**TENDER 16-20**  
**WATER TREATMENT BUILDING**

**ADDENDUM NO. 6**

**October 12<sup>th</sup>, 2016**

TITLE: PROPOSED RAW WATER SUPPLY MAIN HIGHWAY #28 TREATMENT BUILDING - CONTRACT 2	DRAWING NO. 15-508- P105
MECHANICAL PROCESS SECTIONS - SHEET 2 OF 2	PROJECT: 112311316
	REV. 5

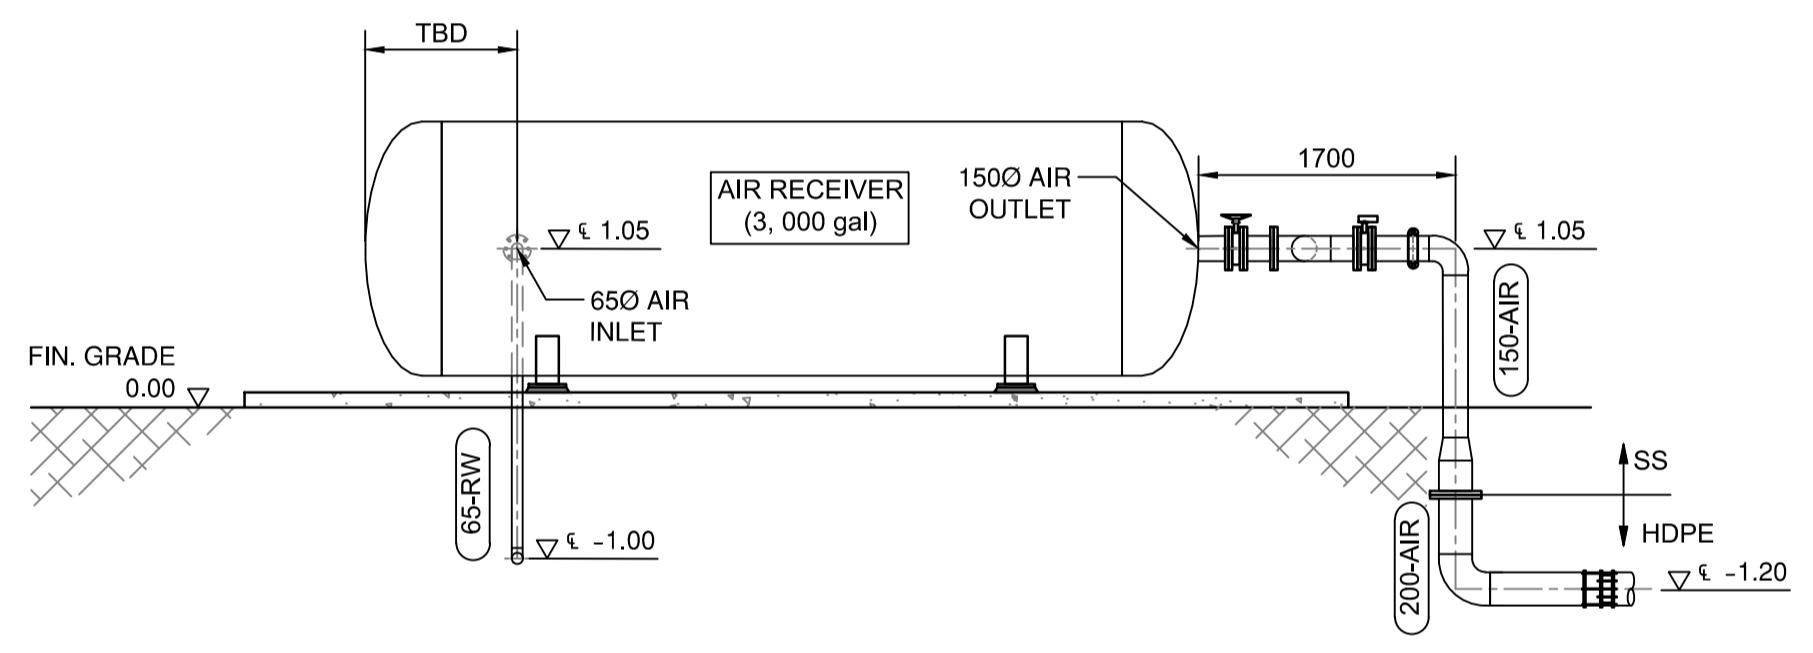
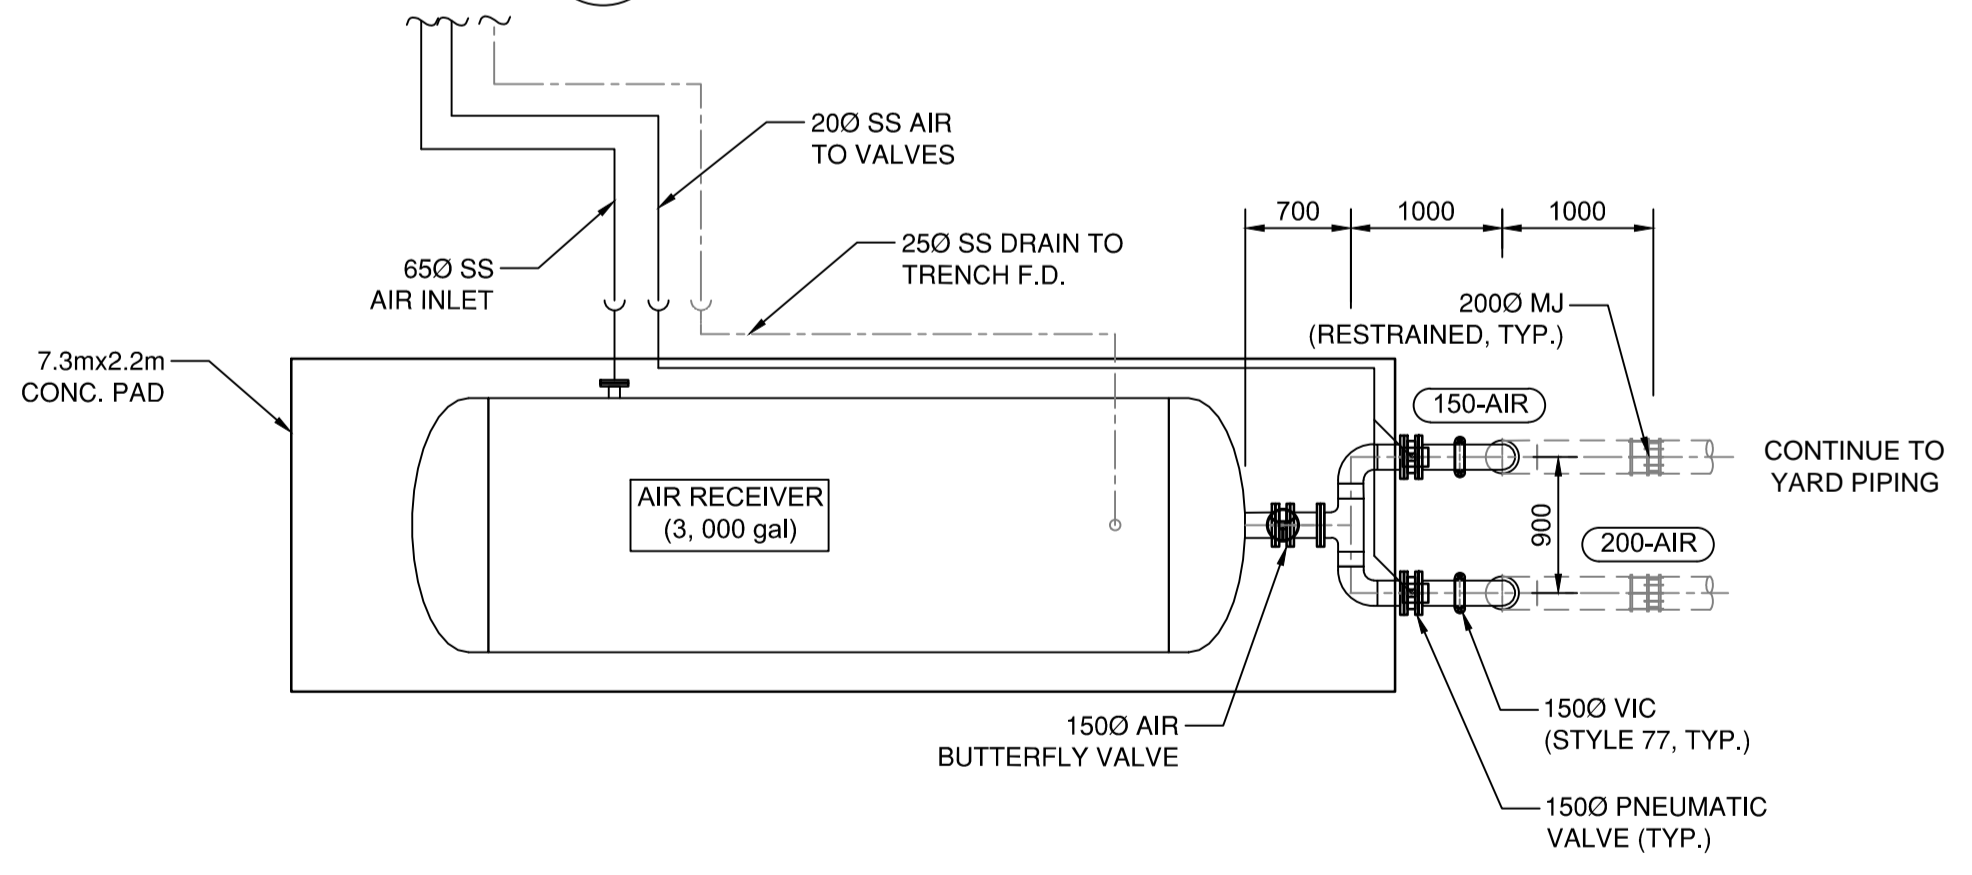
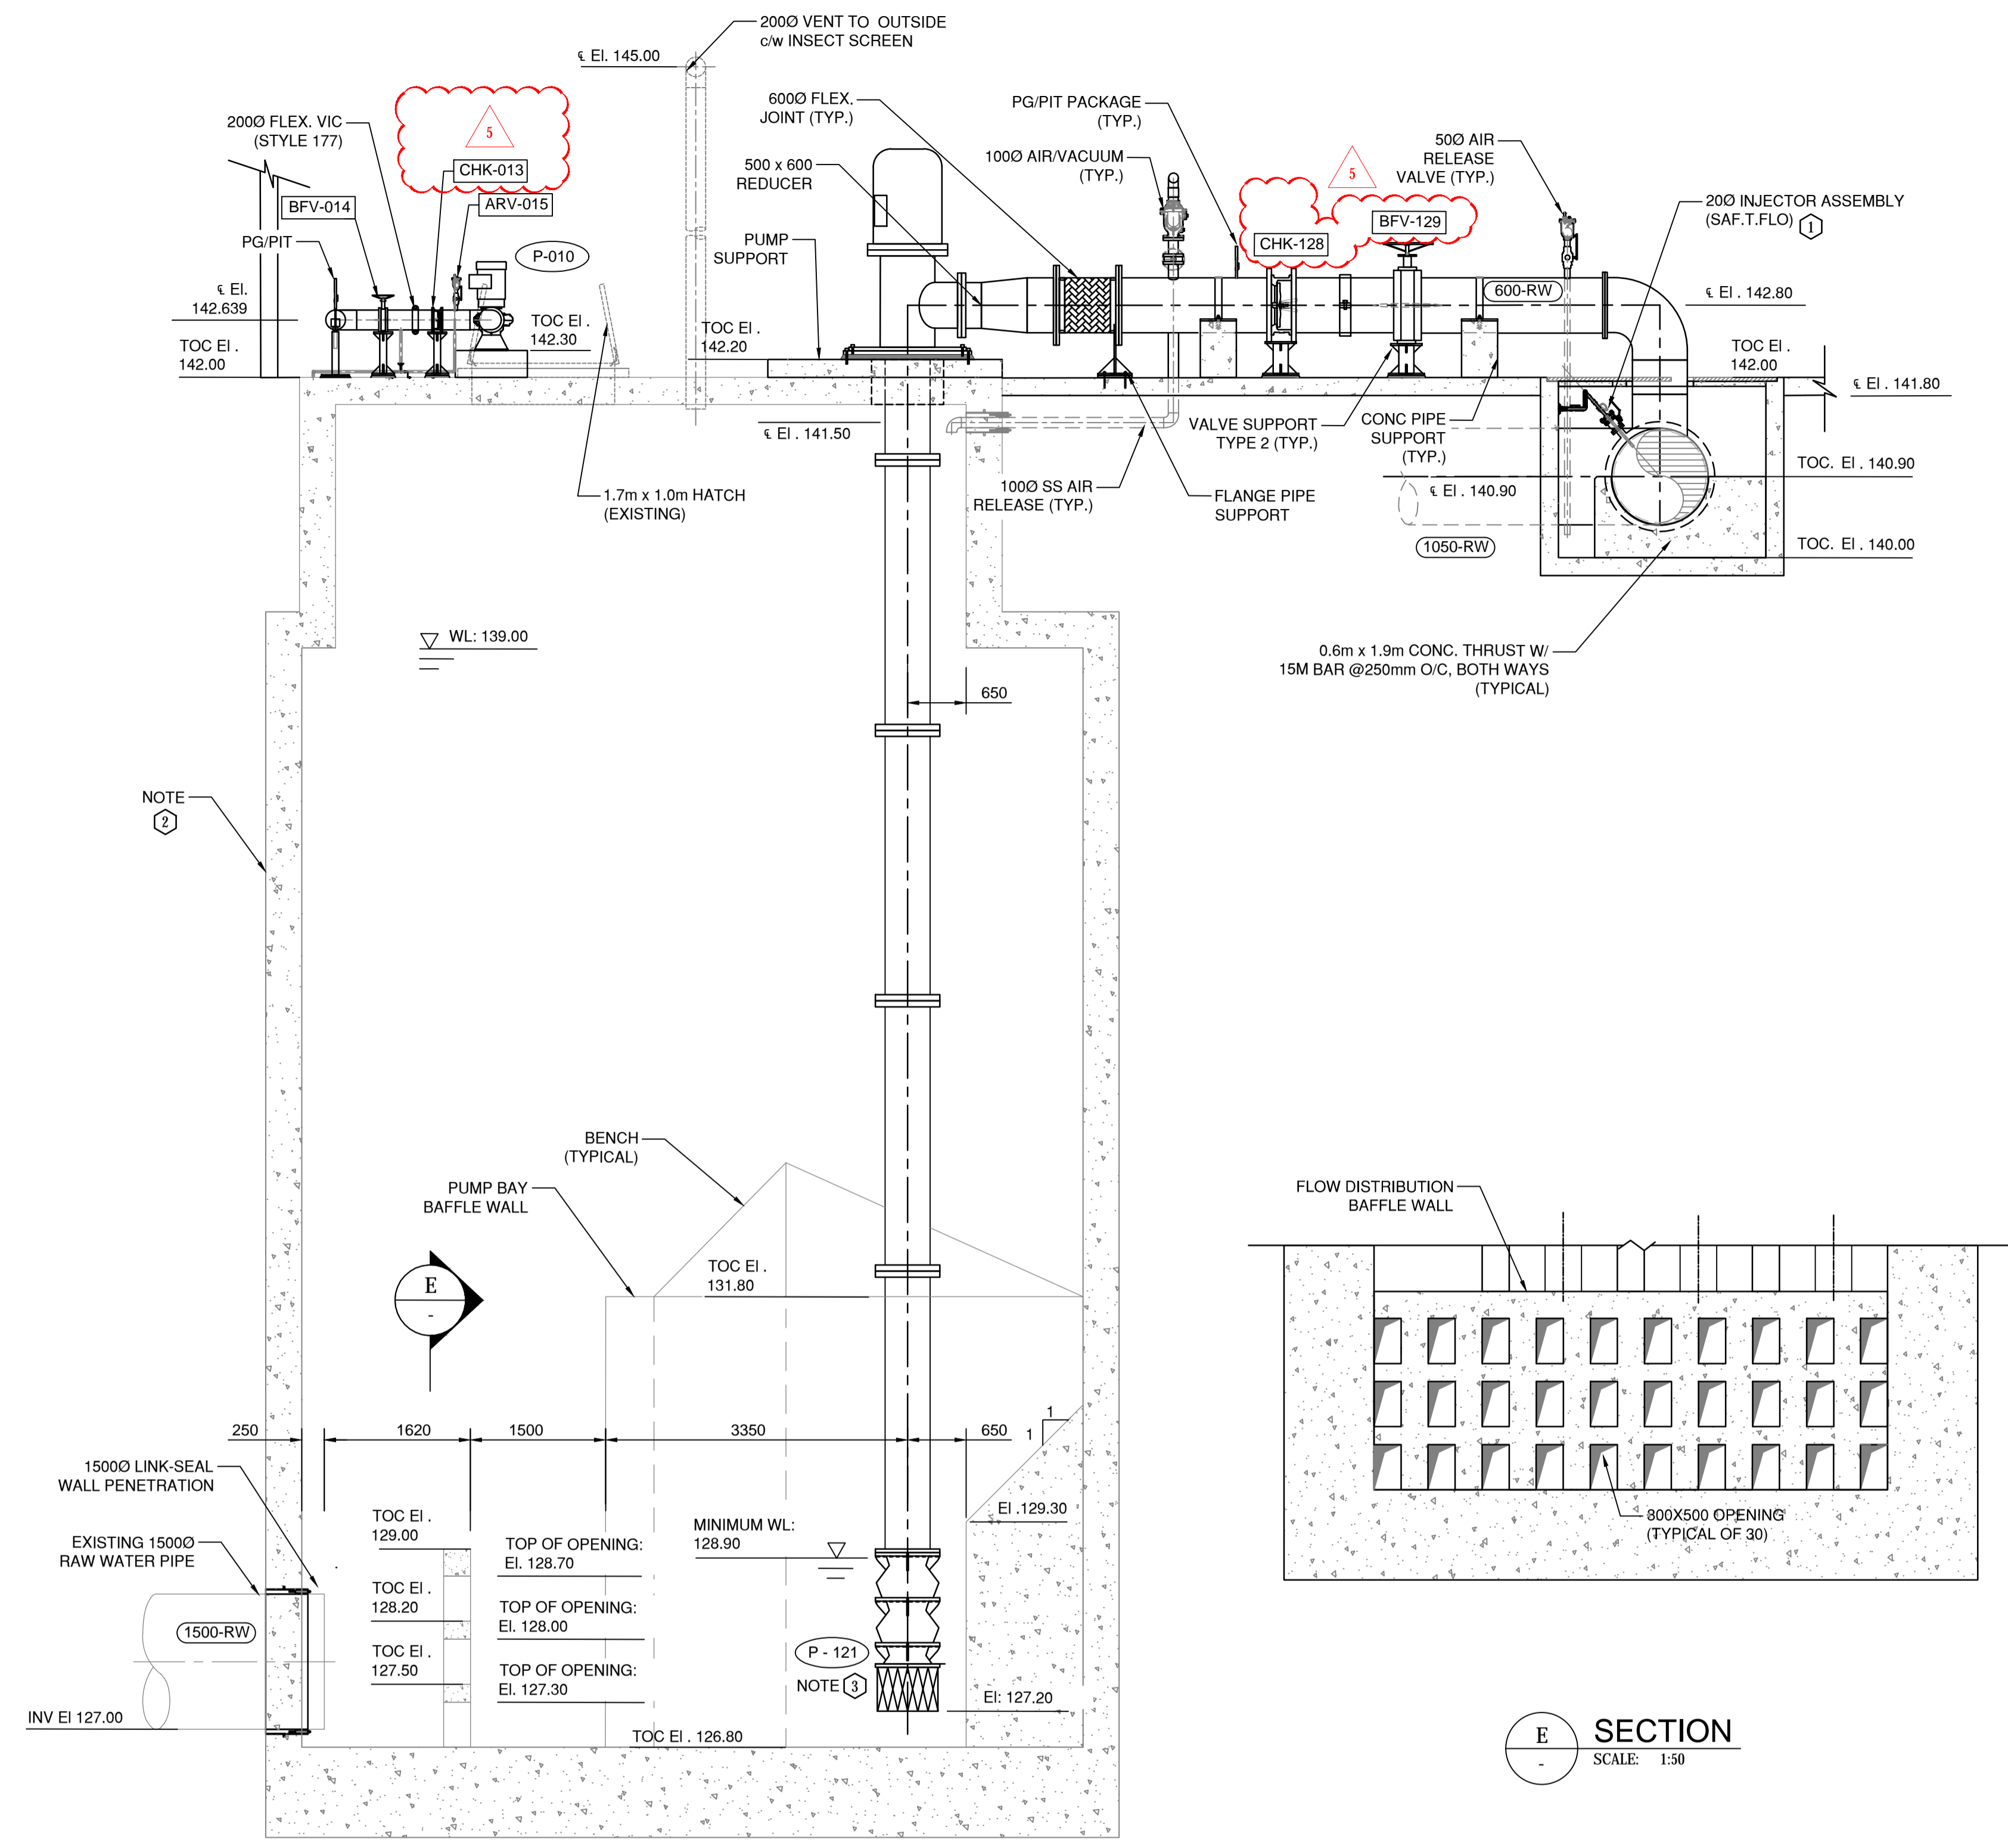
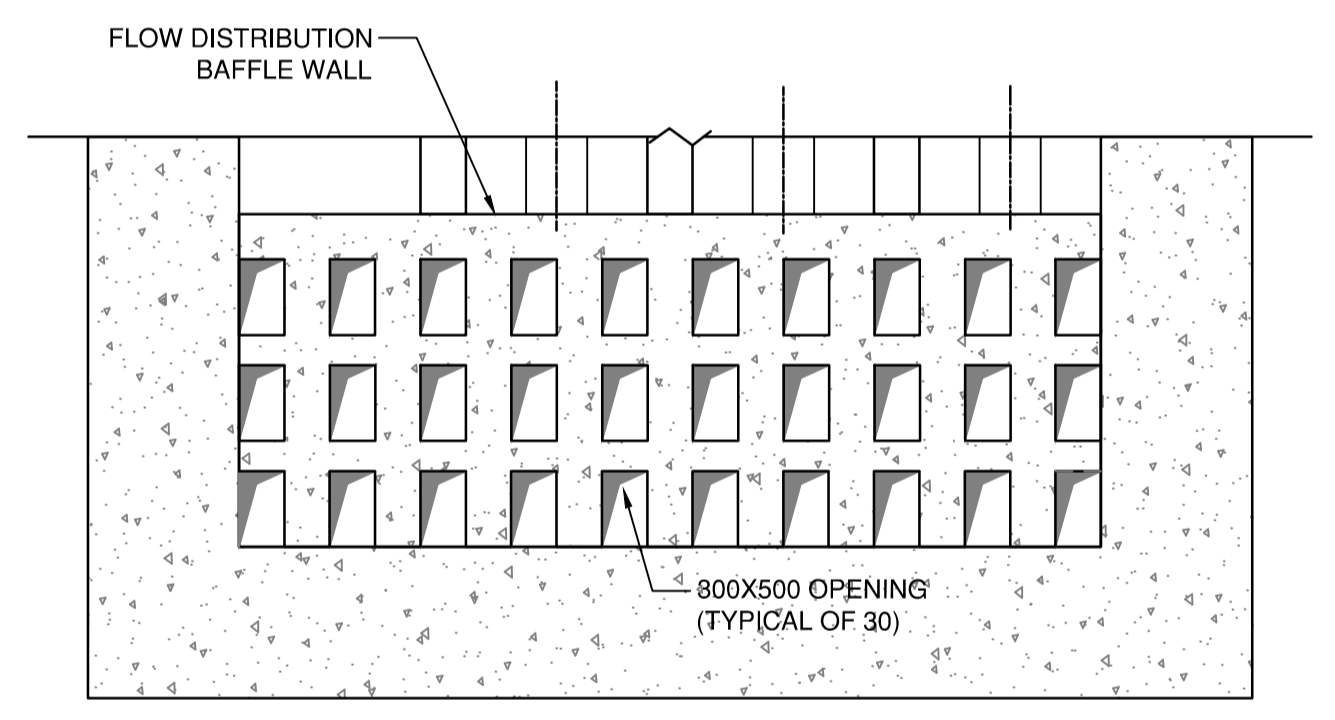
Process valve tags on drawings differ from that in section 40 06 23, do you know which is to be correct?

Updated layout drawings and spec provided.

Refer to the attached drawings and specifications that address the valve labeling discrepancy.
